In its [February 28th](#) and [June 20th](#), 2024 presentations of the X-178 project to the PAC Eversource provided condition categories but failed to provide the recommended actions.

SEC 2024-02 DE-24-087

kris pastoriza

January 6, 2025

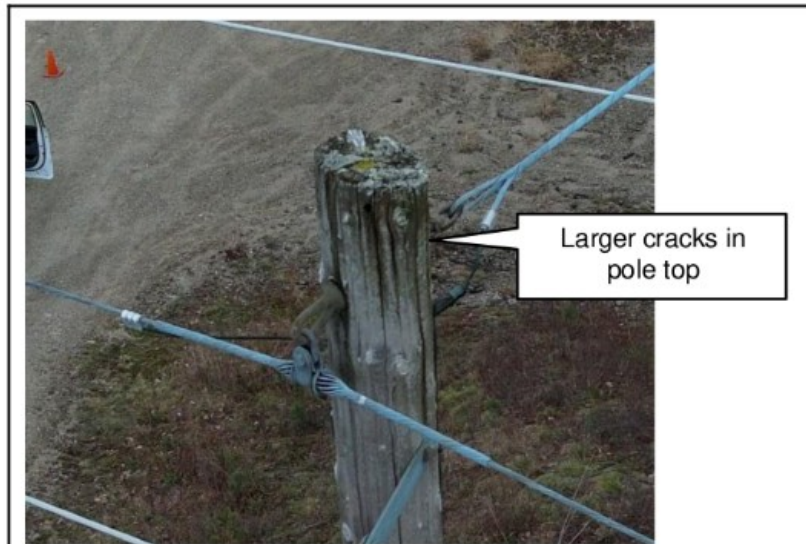
The photographs Eversource provided in its October presentation to the PAC, purporting to show degradation since 2022 do not meet any standard of evidence:

Above:

Photo of dry pole

Cross-arm anchor facing toward viewer

No white marking on r. side of ground wire

Ratio of ground wire attachment 4: 2.4

Photo of wet pole

Anchor facing 90 degrees left

Cracks labeled as larger not visible in 2022 photo

White band on r. side of ground wire

Ratio of ground wire attachment 3: 3.5

This ratio difference could be due to the fact that the photos are not comparable. Note that the cross-arm brace anchor appears to end at ground wire in the 2022 photo and the cross-arm brace anchor is clearly seen to end below the ground wire anchor in the 2024 photo.

The cross-arm that was replaced would have been easy to photograph after it was removed and on the ground but Eversource chose not to show its condition.

It is not clear that these photos are even of the same pole.
